# Critical Review of the Root Cause Investigation of Crystal River Delamination

DECEMBER 2019

VICTOR E. SAOUMA

Figure 11: Comparison of PII computer model predictions for radial displacement from pass 4 through pass 11 at various elevations to the laser scanning data (ADAMS Accession No. ML 102861026, 2010)

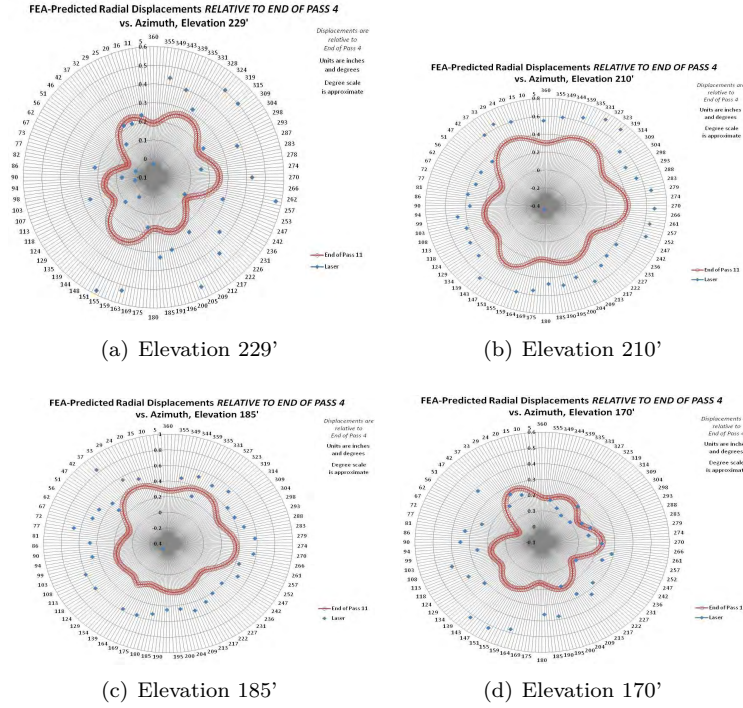
“Benchmarking” of the code results are inconclusive at best. SIT (in theory) should not have induced any nonlinearity (cracking or otherwise), hence excellent correlation between measurements and computations should be expected. Indeed adequate correlation is reported, however this does not necessarily validate the code for nonlinear analyses.

Validation with the 2010 detensioning is inconclusive as there are too many variations in laser readings, and errors bars are not included for either of the two reported values (experimental or numerical). The term “Benchmarking” is unfortunate, a more traditional term would have been “Validation” or possibly “Calibration” (as it is reported later that elastic properties have been modified to yield adequate correlation between numerical findings and field observations).

Figure 12: Group 1 Finite element Analyses (ADAMS Accession No. ML 102861026, 2010)

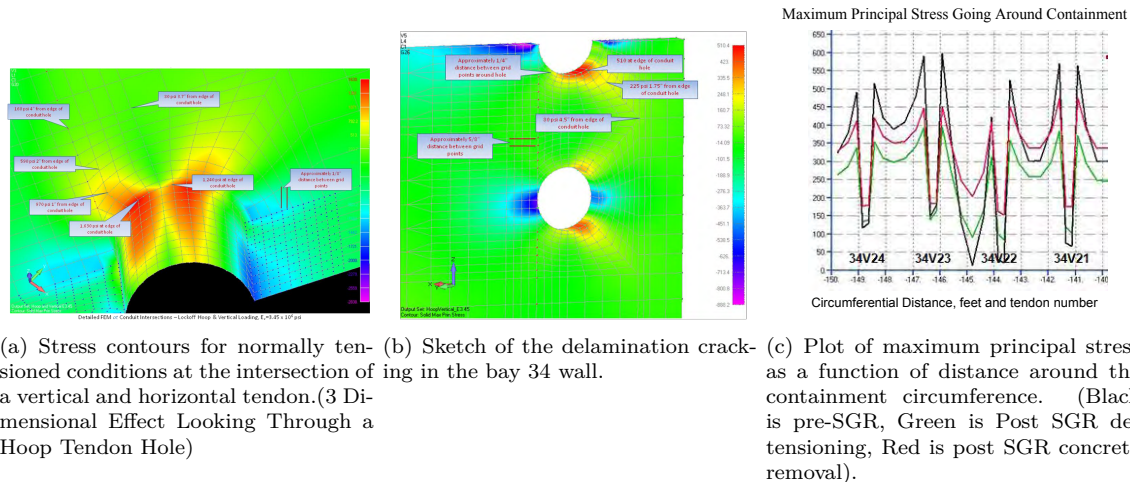
The report addresses the finite element model used for group 1. We find it confusing. The authors start by professing not to use NASTRAN to quantify fracture, and as such fracture parameters are not applicable. Yet ever since the pioneering work of Hillerborg, Mod  er, and Petersson (1976) any modern investigation of concrete fracture would have to use fracture mechanics. The website of the International Association

A particularly troublesome approach taken by the authors is the liberty with which material properties are at times modified to match intended results. In the table,  $E_0$  is equal to  $3.45 \times 10^6$  in the Abaqus analyses, and 4.29 in the NATRAN analyses, Table 2.

Figure 14: CR-3 bay 34, cracking and crack opening displacement (ADAMS Accession No. ML 102861026, 2010)

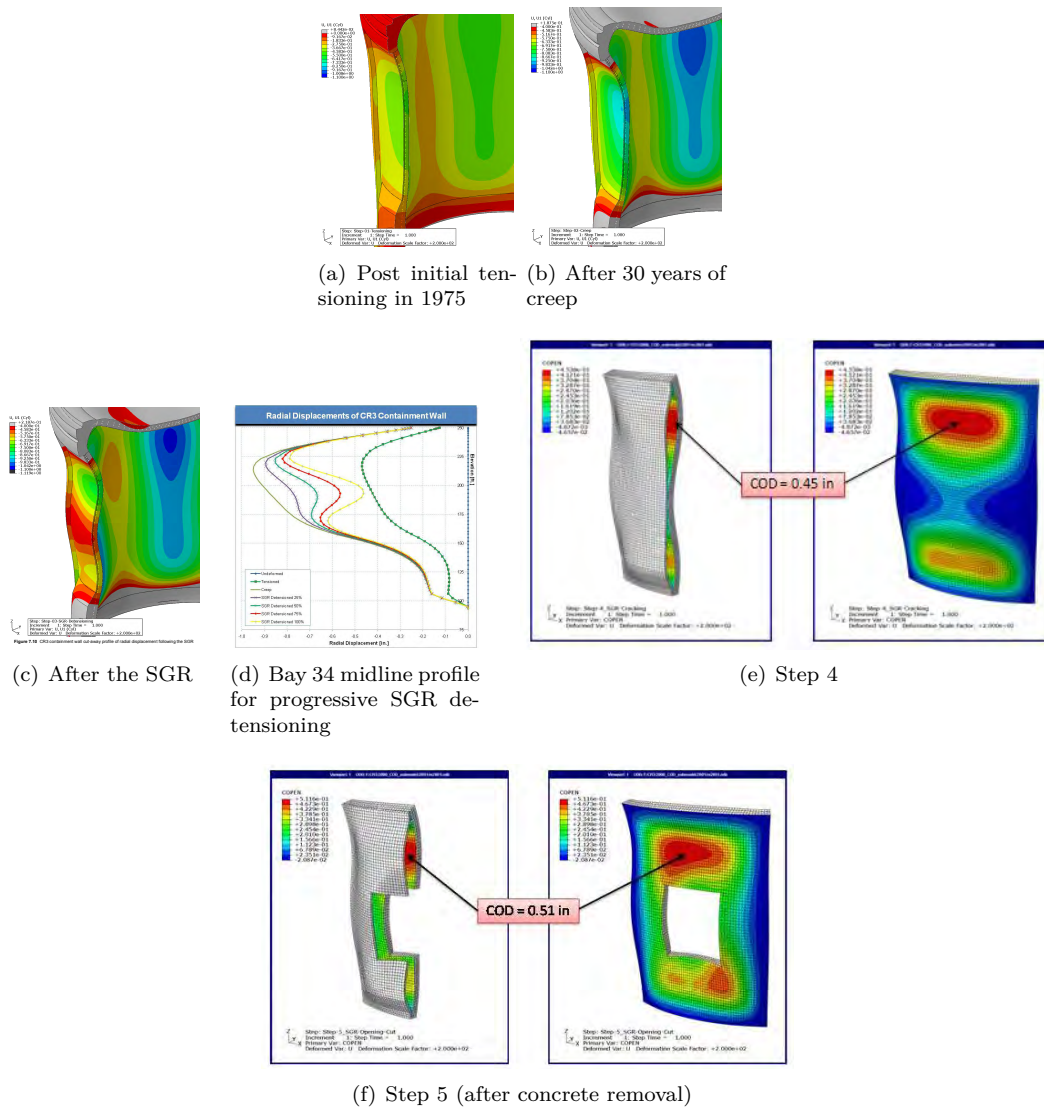
Keeping in mind that there is a one way coupling (that is from global to the detailed model) and that the simplified linear elastic global model was able to capture delamination (Fig. 14(e), 14(f)) why was there a need to perform the detailed analysis and then capture the delamination in Fig. 8?
